BELL SYSTEM PRACTICES
 Teletypewriter Stations

ADDENDUM P30.411
 Issue 1, November, 1957
 AT&T Co Standard

NO. 14 TELETYPEWRITER AND TYPING REPERFORATOR INTERNAL WIRING VARIATIONS

- 1.001 This addendum supplements Section P30.411, Issue 6.
- 1.002 This addendum is issued to add wiring plan M1.32.
- 1.03 Add the following:

M1.32 CONNECTIONS TO EXTEND LINE MAGNET CIRCUIT THROUGH EXTERNAL JACKS
 (14AB TYPING REPERFORATOR BASE)

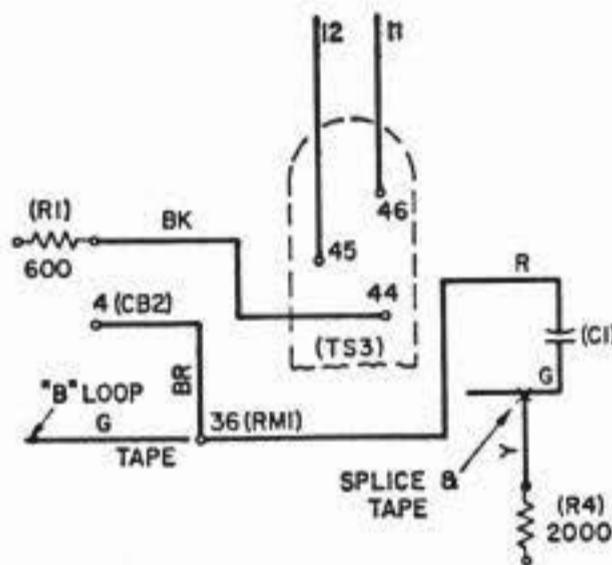
Plan No.
 M1.32

Title
 Connections to Extend Line Magnet
 Circuit Through External Jacks (14AB
 Typing Reperforator Base)

| COLOR | FROM | TO | CHANGE |
| G | (C1) | 44(TS3) | REMOVE FROM 44 (TS3) |
| Y | (R4) | 44(TS3) | SPLICE & TAPE |
| G | 36(RMI) | B LOOP | REMOVE FROM 36(RMI) & TAPE |
| BK | (R1) | 46(TS3) | REMOVE FROM 46 (TS3) CONN. TO 44 (TS3) |
| R | (C1) | 45(TS3) | REMOVE FROM 45 (TS3) CONN. TO 36 (RMI) |
| BR | 4(CB2) | 45(TS3) | REMOVE FROM 45 (TS3) CONN. TO 36 (RMI) |
